# BSC Cable Trays ... again:

Evaluation of an LLO Proposal for an Alternative Design

G1200110-v3

# Alternative BSC Cable Tray Design

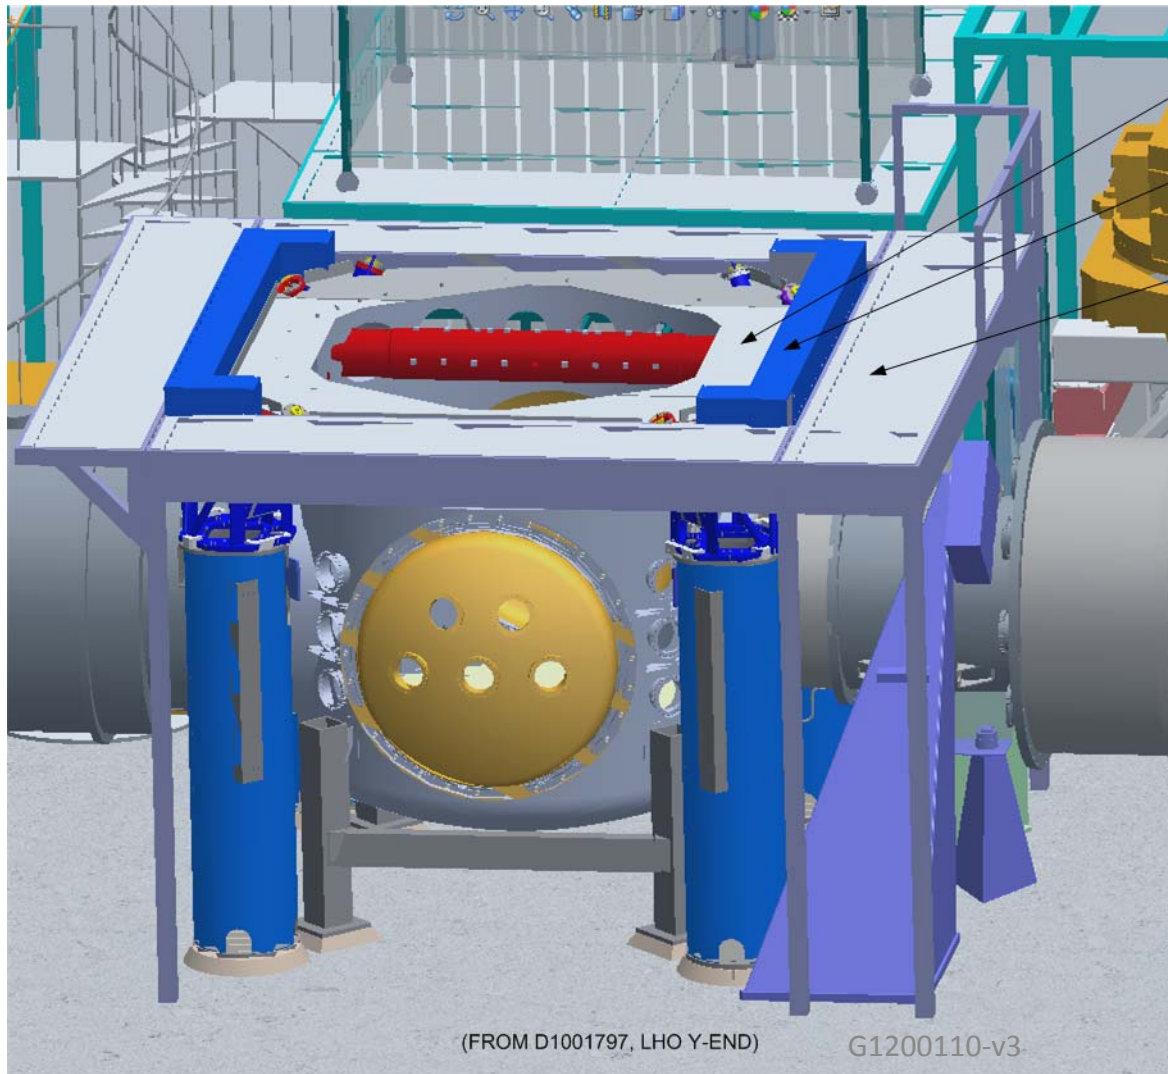
- Cons
  - No cable restraint
  - 3 to 4 ft long unsupported cable lengths from feed-through to tray
  - Limits the positioning of the BSC Cleanroom – OK?

- Interferes with Work Platform → Fatal Flaw, but see possible modifications
  - Interferes with BSC Cleanroom corner braces → Fatal Flaw, but see possible modification

- Unsupported tray length likely too long → but see possible modification
  - Adds significant mass to HEPI support piers which effect dynamics → potentially fatal flaw

# Interference with Work Platform (D1001990)

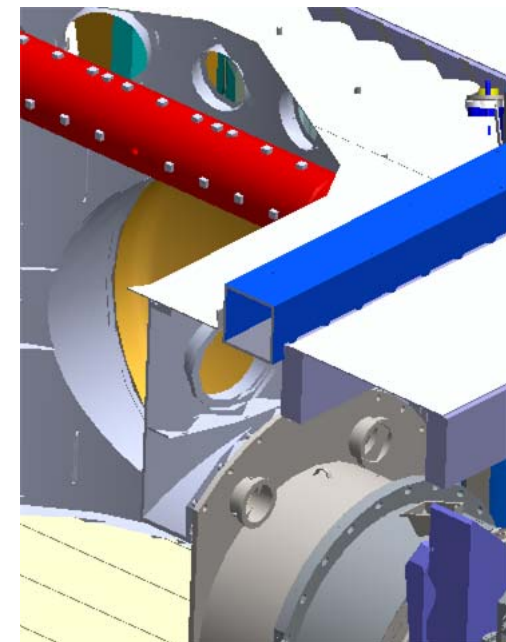
WALKING PLATE  
CROSSBEAM  
WALK PLATFORM  
INTERFERES WITH  
PROPOSED BSC CABLE  
TRAY LOCATION
